Regarding the calculations:

New approach

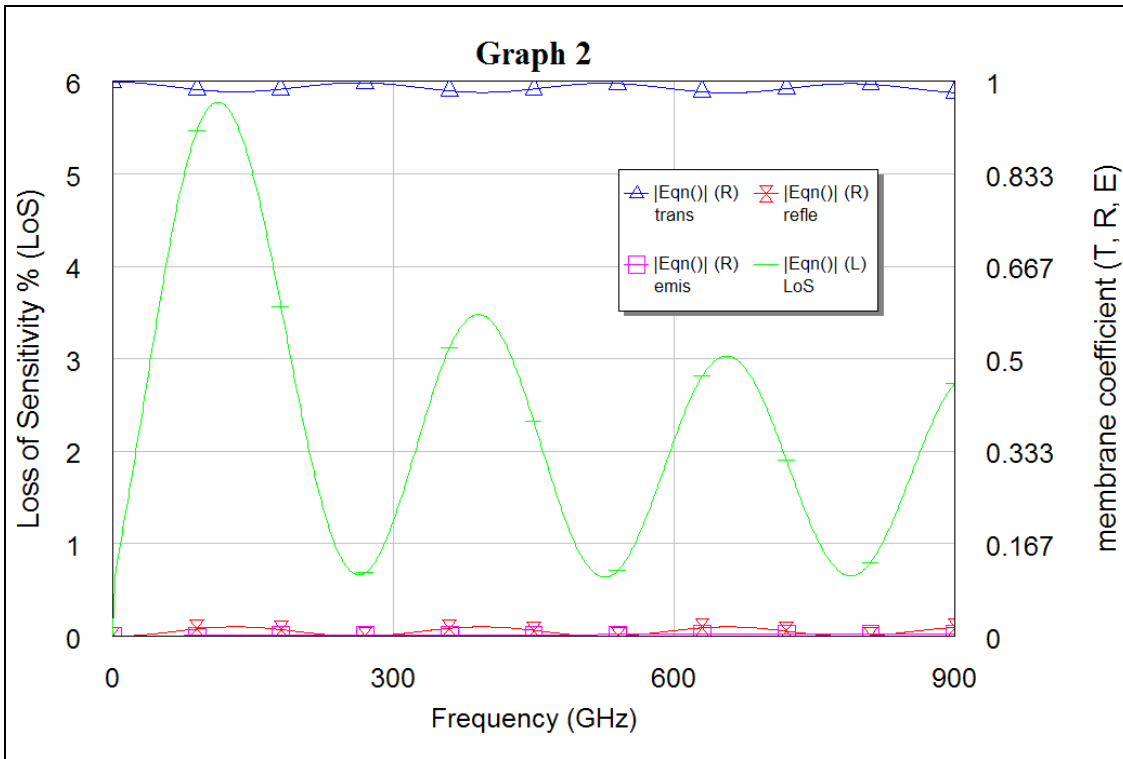
I split the contributions and calculated (using the same transmission line model) the coefficients of Transmission, Reflection and Emission for the Gore-Tex membrane.

Following the formula you proposed in the Excel sheet, I calculated the Loss of Sensitivity as:

Loss of sensitivity $E_r=1.3$, $Att=30\text{dB/m}$, $L=500\mu\text{m}$ (linear model for T_{sys})

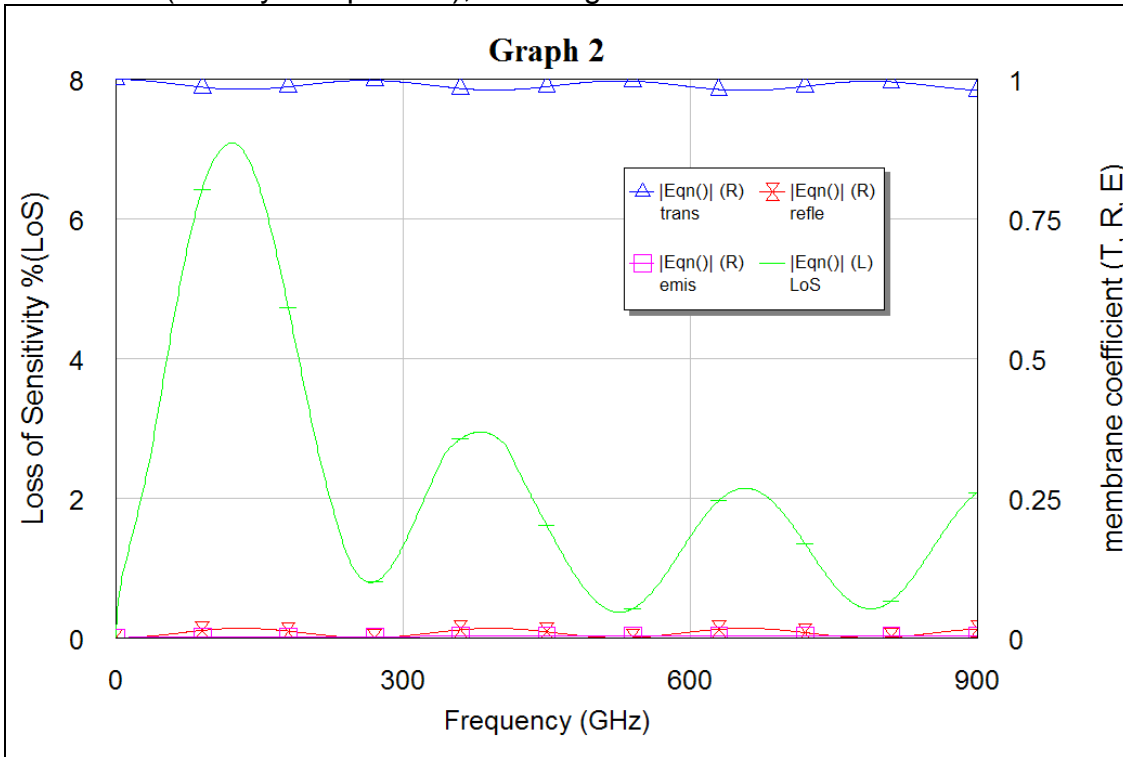
I obtained figures very similar to your results, with a modest improvement of performance.

I used $\text{Er}=1.3$ and $\text{Att}=30\text{dB/m}$ which seems to me the worst cases.
